Docket Item #21
BAR CASE 2006-0049

BAR Meeting
March 15, 2006

ISSUE: Addition
APPLICANT: B.J. Anderson
LOCATION: 412 Gibbon Street
ZONE: RM Residential

Figure 1 - Rear elevation

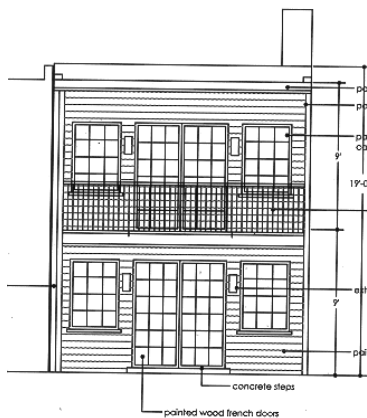
Staff believes the proposed addition is acceptable. The addition will be minimally visible from Royal Street. It is reasonable in size and is compatible with the existing house and neighboring properties in its mass, scale, materials and architectural detailing. Staff notes that the applicant intends to use simulated divided light windows. According to the *Design Guidelines*, true divided light windows are preferred, but simulated divided light windows are acceptable where they will have minimal visibility from the public right-of-way, as in this case (Windows- Page 3).

The siding will be used on new construction and thus meets the item #1. However, Staff notes item #s 4 & 5 and recommends that they be included as a condition of the approval. Lastly, Staff notes the comments of Alexandria Archaeology and recommends that they be included as a condition of the approval.

1. That the fiber cement siding be smooth and that the nails not show in the installation;
2. That the following statement must appear in the General Notes of all site plans and on

Figure 2 - East side elevation

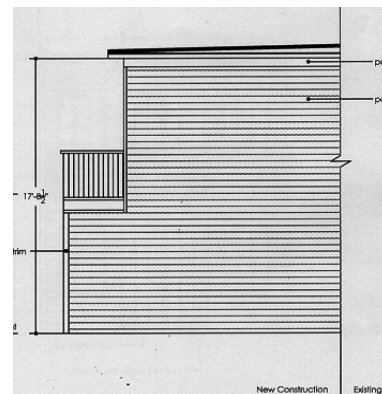
The west side wall of the proposed elevation will abut the existing east wall of the house at 414 Gibbon Street for its entire length and will not be exposed. On the other hand, the east wall of the proposed addition will be exposed for its entire 16'-6" length. As the wall will be on the lot line, no penetrations are permitted by code. The east wall will be clad in the same fiber cement siding as the rear facade.
